A meeting of the **WAVERLEY LOCAL PLANNING PANEL** will be held by video conference at:

AGENDA

14 Glen Street, BONDI NSW 2026 - Amended: Substantial alterations and additions to dwelling house, including first and second floor additions, a front hardstand car space* and a swimming pool in the rear yard. (DA-389/2021)

Report to the Waverley Local Planning Panel

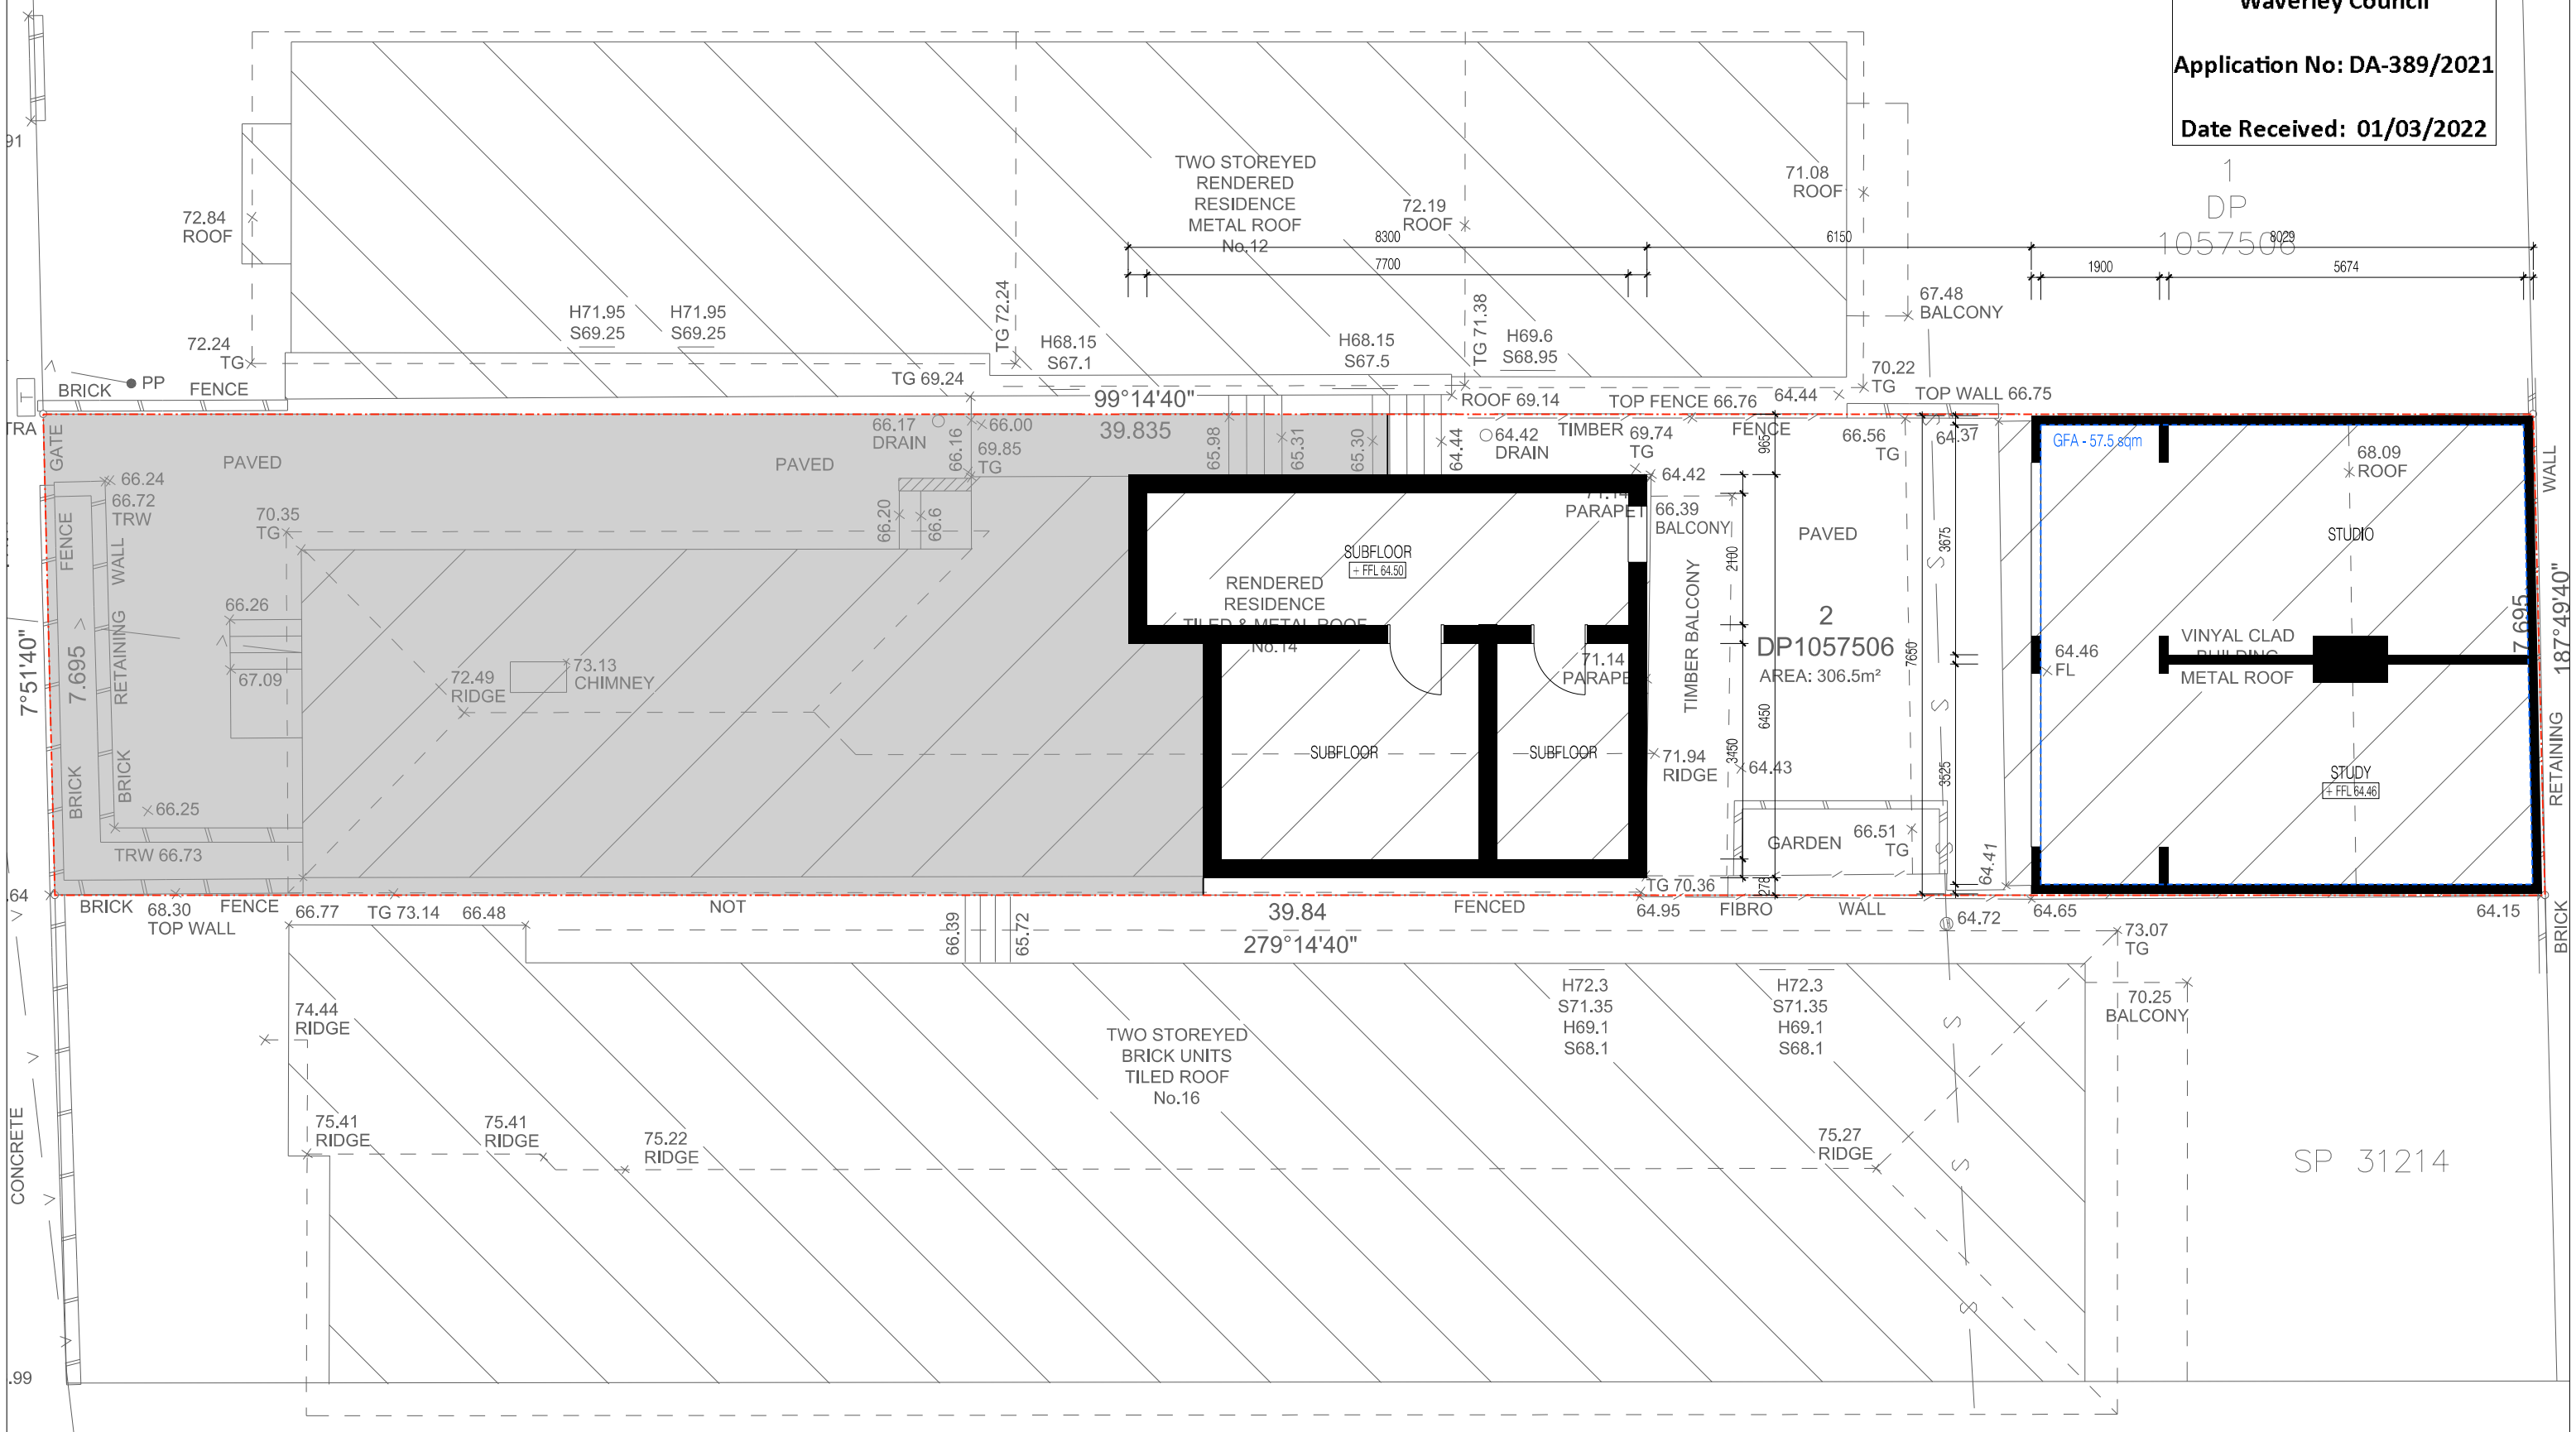
The assessment finds these issues acceptable on merit and for the specific reasons outlined in this report. A condition of consent is recommended to delete the enclosed void to the rear of the first floor level to minimise bulk and scale and overshadowing impacts upon neighbouring properties.

Project	7 Park Parade, BONDI
Drawing Name	Proposed Section A
Project Number	2103
Drawing No	DA-06.1

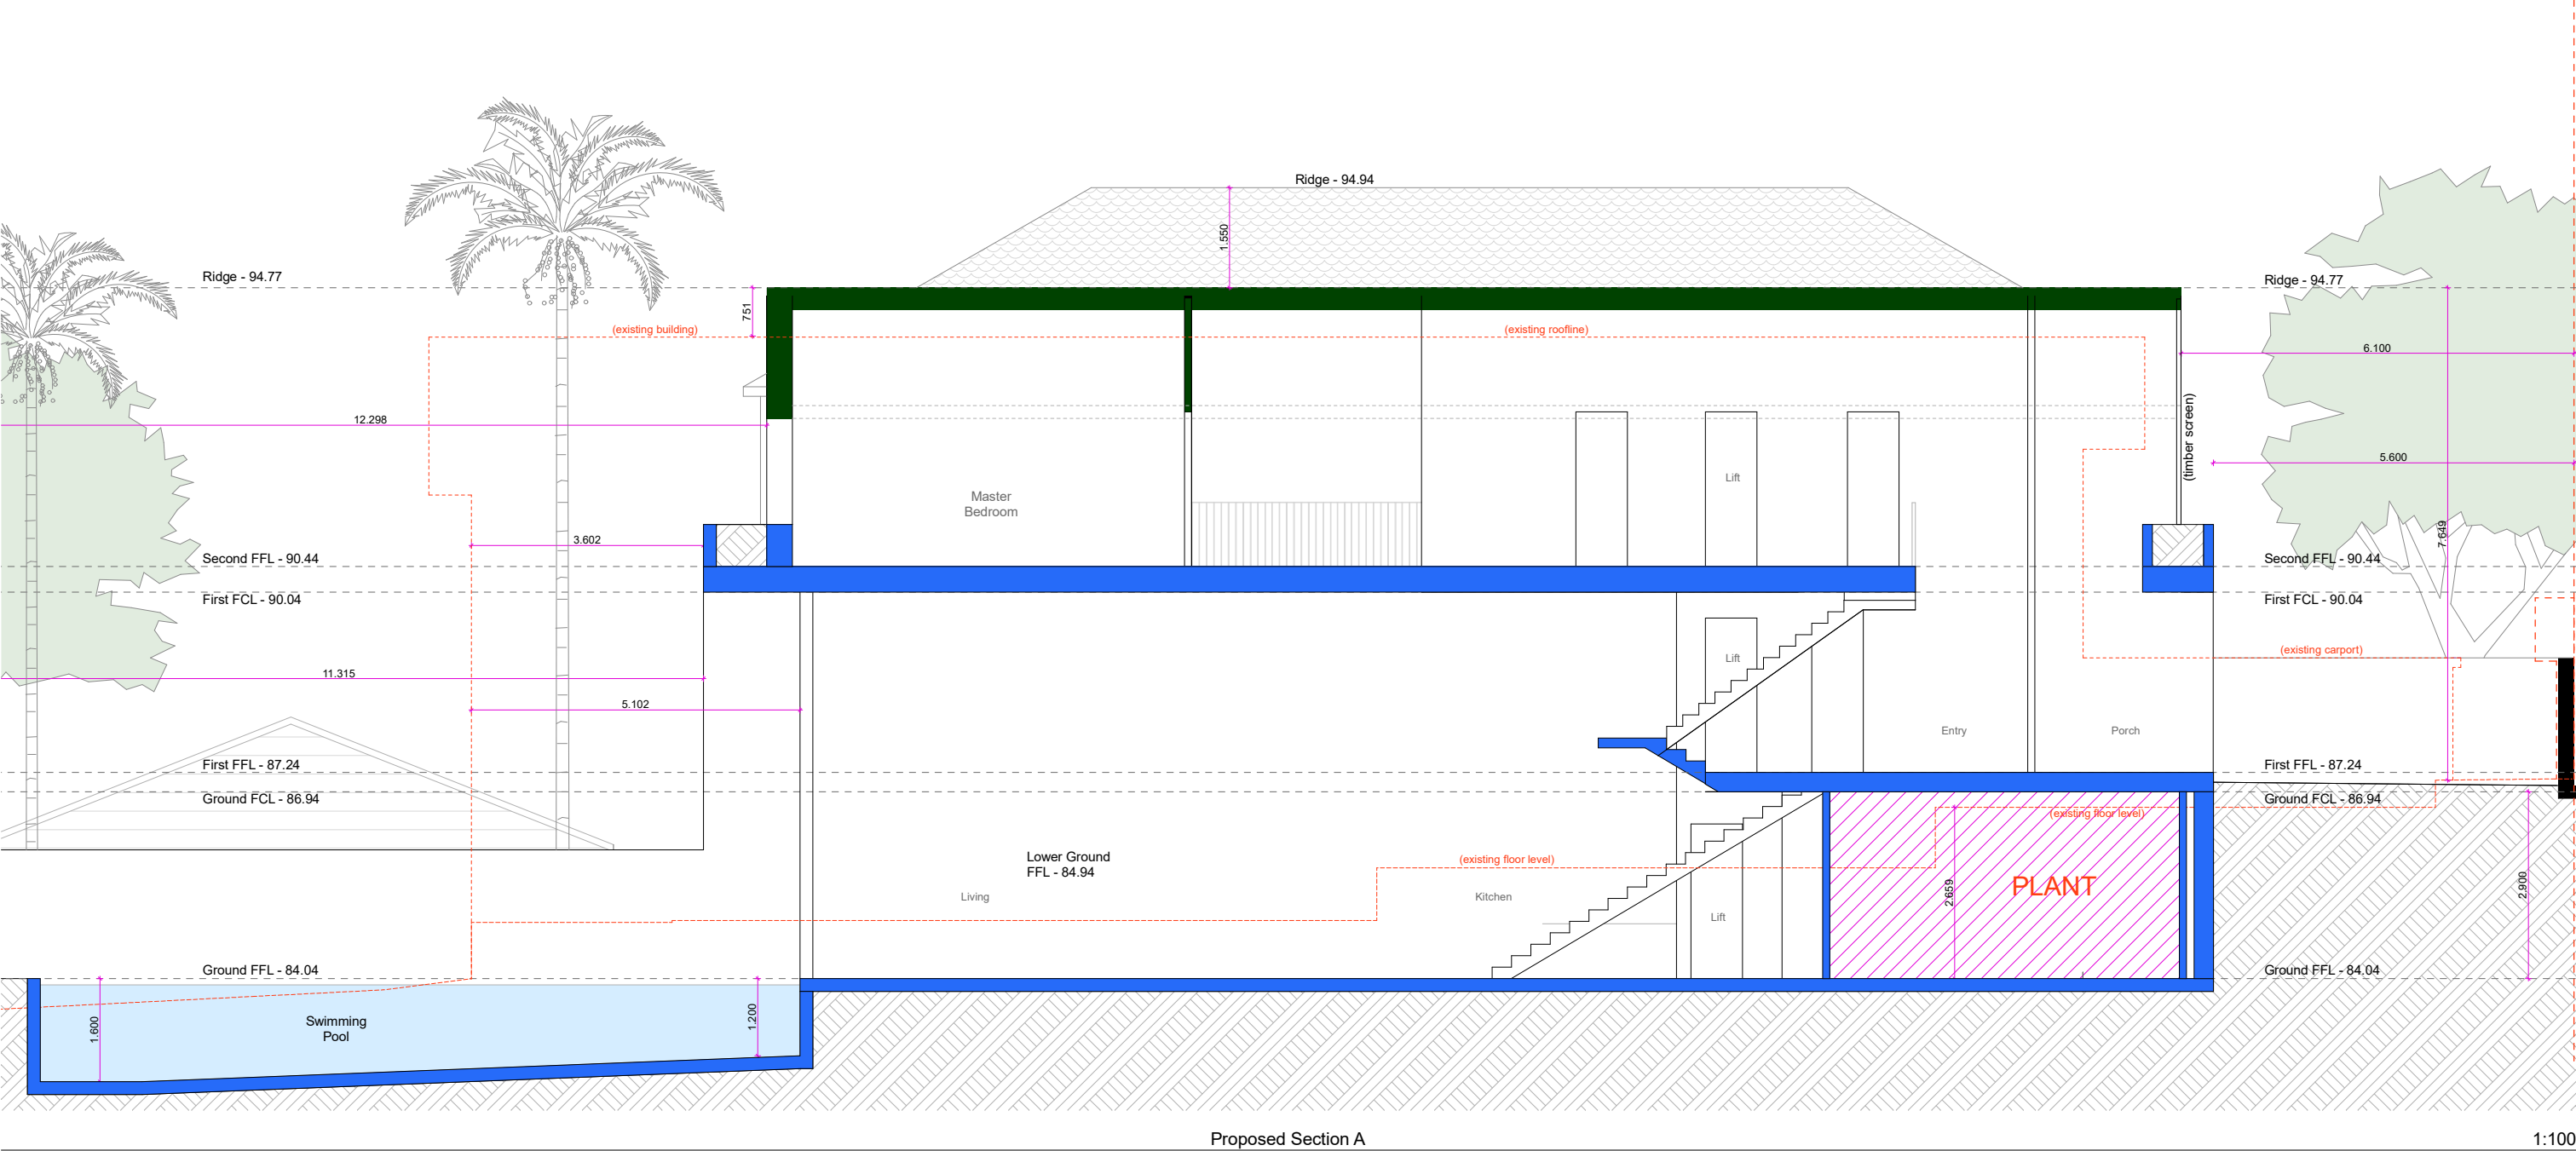
The proposed voids and excessive floor-to-ceiling height unnecessarily increase the height, bulk and scale of the proposed building. The large void shown in Figure 6 below has a ceiling height of 6m which equates to a two-storey void for the majority of the lower ground floor level. This void would be easily converted to gross floor area in the future (subject to consent) which would result in a significant exceedance of the FSR development standard. In this regard, the proposal does not provide an appropriate correlation between height and density which supports the argument that the proposal does not meet the desired future character of the area and is inconsistent with objective (b).

Figure 6. Proposed Section A, demonstrating excessive voids (outlined red). (Source: Stephen O'Connor Architecture, 2022)
